SUBJECT: Tentative approval of the request of Erickson Living of the Revised Special Land Use permit, Revised Preliminary Site Plan with PD-1 Option, Revised Phasing Plan, Revised Wetlands Permit, Revised Woodlands Permit, and Revised Storm Water Management Plan, JSP 18-18. The property is zoned RM-1 (Low Density Multiple Family) and is approximately 102 acres. It is located in Section 1 of the City on the north side of Thirteen Mile Road, west of M-5 and east of Meadowbrook Road. The applicant is proposing to revise the original approval and layout of Phase 3 of the Fox Run senior community. The four buildings would contain 370 independent living units along with dining, gardens and enrichment facilities.

FOX RUN NEIGHBORHOOD 3: JSP 18-18

Fox Run Neighborhood 3
Revised Preliminary Site Plan
JSP18-18

OVERALL SITE PLAN

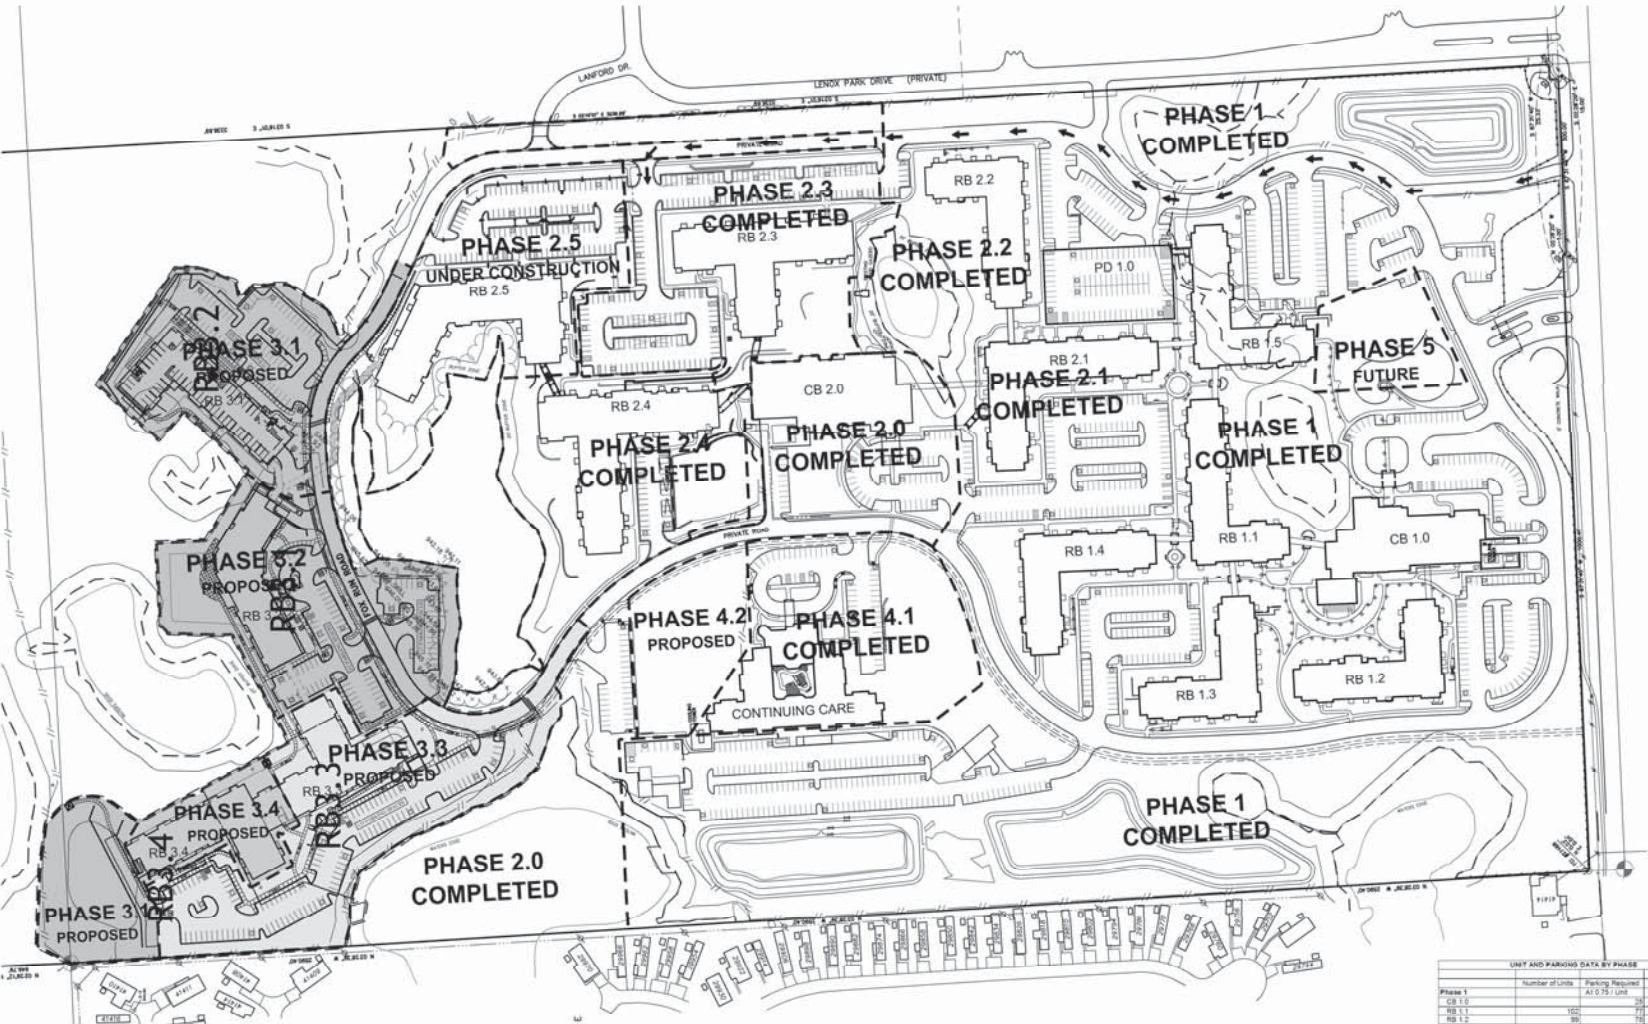
1. Phasing Plan: Sheet C100, the Overall Site Plan, has overlapping and contradictory labels for the phases in Neighborhood 3. Phases 3.1 and 3.2 are reversed from our current understanding of the construction schedule. **Please clean up and clearly label each phase to be consistent with the rest of the plan set.**

5. Overall Site Plan: Ensure sheet C100 reflects the most current designs for all buildings, roads and parking areas on the Fox Run site. **The phase 4.2 area should reflect the planned building layout for the proposed addition to the Continuing Care Center as reflected in the revised Final Site Plan under review.**

Deviation request Building length:

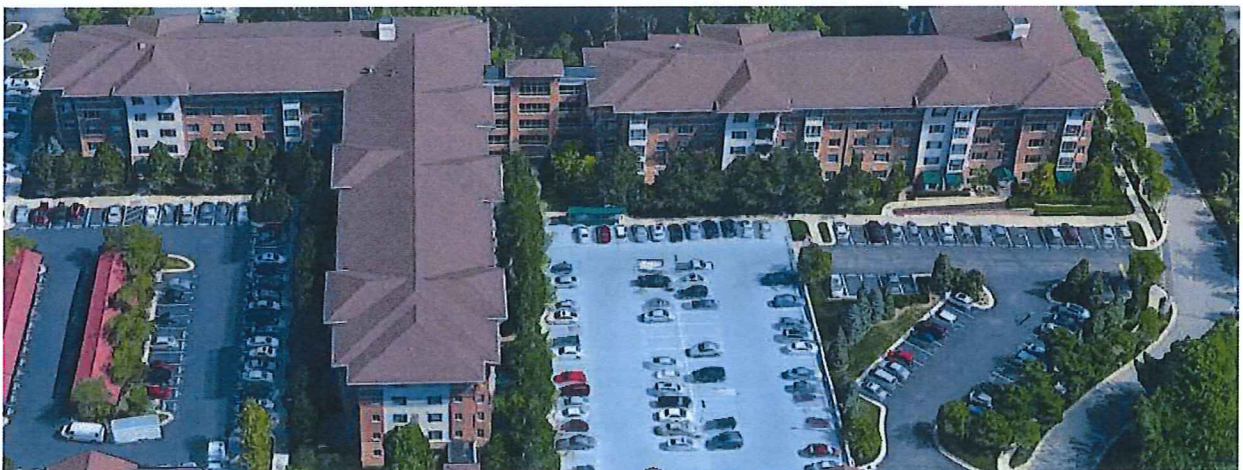
All buildings within the existing Fox Run Community are interconnected with pedestrian links, which provide protection from the weather as rain, snow and heat.

This concept allows the senior living residents to move around independently at their own pace to visit the dining venues, live enrichment areas as movie a theater, arts and crafts, game room, etc., or their neighbors. Some residents are fragile and need the handrail support provided along the corridors and pedestrian bridges others use walkers and canes.

Fox Run RB 3.1 Proposed 7 Stories

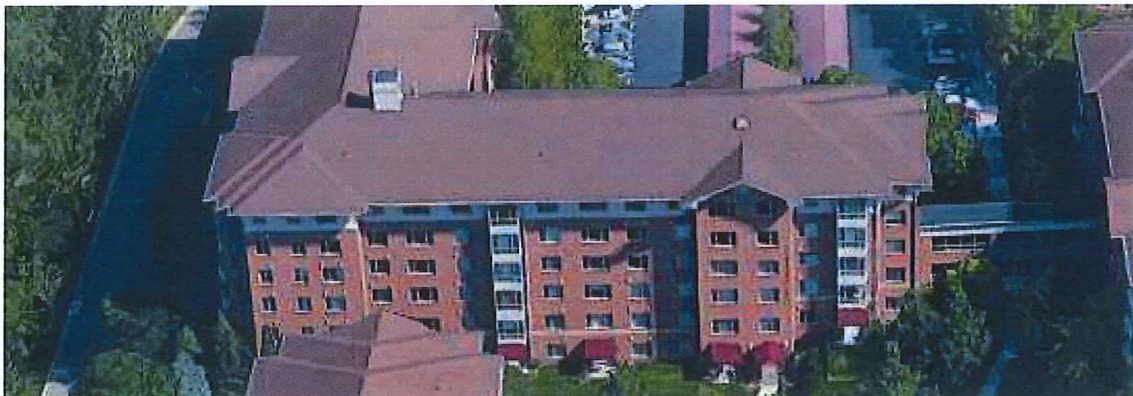
The Silent Generation of seniors, born between the years of 1927 and 1945 prefers retirement campus with larger resident units. The average unit size of proposed neighborhood 3 is about 1200 SF in average compared to the 1000 SF average unit size of Neighborhood 1.

Neighborhood 3 was originally planned for 370 resident units as a 5-story building scheme. 370 units are needed to provide a feasible project and balance out the staffing, life enrichment areas as pickle ball, movie theater, game room, and dining venues. We are proposing 370 units as a 7-story building based on the larger market requested unit sizes.

RB 3.1

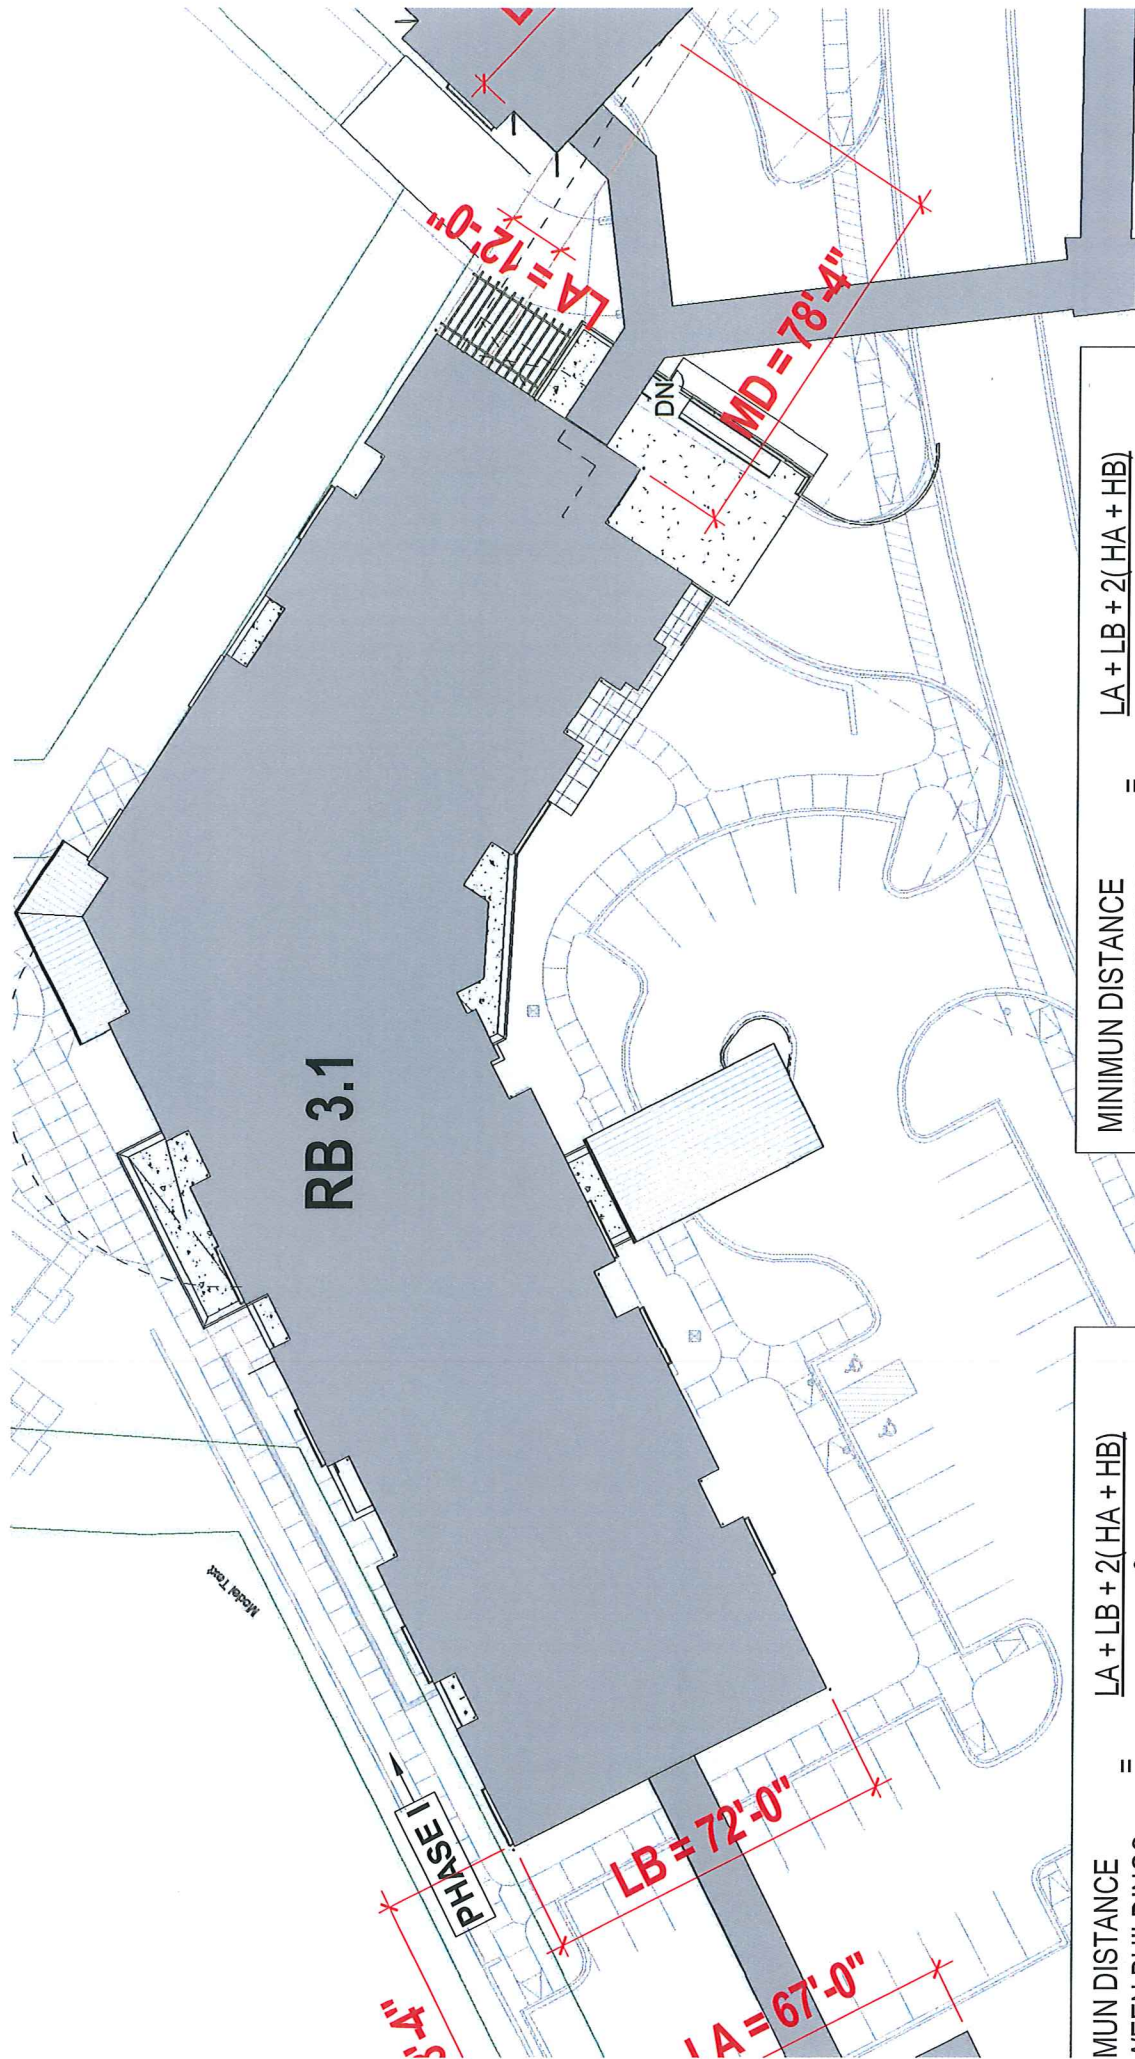
4. Minimum Distance Between Buildings (Sec. 3.8.2.H.): The ordinance provides a formula based on width and height for a minimum distance between two residential buildings in the RM-1 and RM-2 districts. **Using the formula, staff calculates the minimum required distance between RB3.1 and RB3.3 is 81.7 feet. The site plan shows a proposed distance of 77 feet. The applicant should revise the plans to meet the minimum distance or request a variance from City Council.**

Please refer to enclosed sheet PSP-001, which shows that the current proposed design is within the compliance of distances and spacing per 3.8.2.H of the Zoning ordinance.

$$\begin{aligned} \text{MINIMUM DISTANCE BETWEEN BUILDINGS} &= \frac{LA + LB + 2(HA + HB)}{6} \\ \text{MINIMUM DISTANCE BETWEEN BUILDINGS} &= \frac{12'-0" + 72'-0" + 2(90'-1" + 87'-1")}{6} \\ \text{MINIMUM DISTANCE BETWEEN BUILDINGS} &= 73'-0 \frac{1}{2}" \end{aligned}$$
